## Evaluation of Finger Plate and Flat Plate Connection Design

### Response to Questions and Comments

March 28, 2014  
A3292  
Pier 9 Expansion Joint

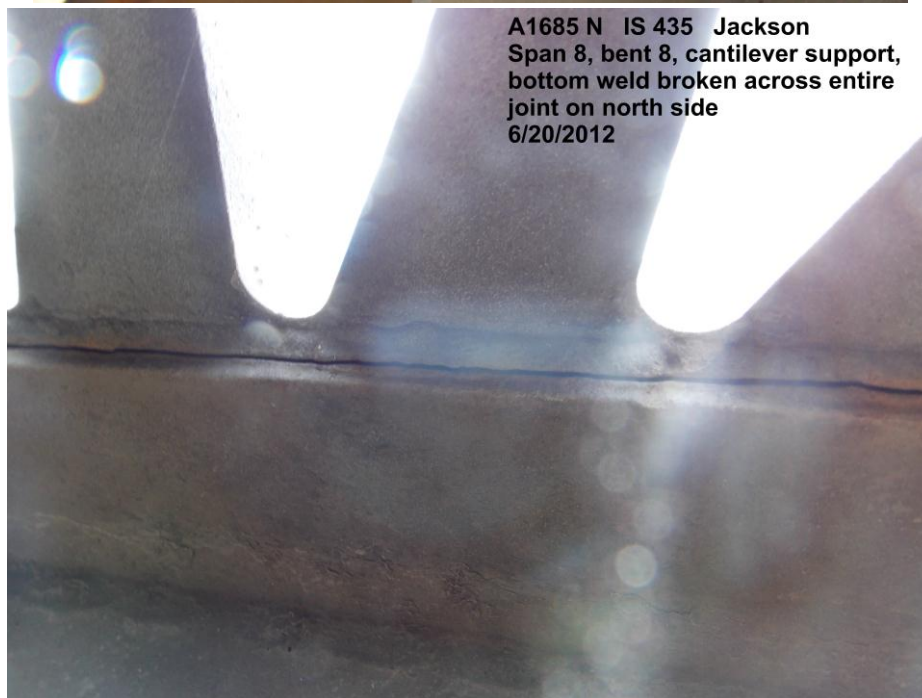
- 1) I was wondering if you could share some additional images of the failures of these joints.
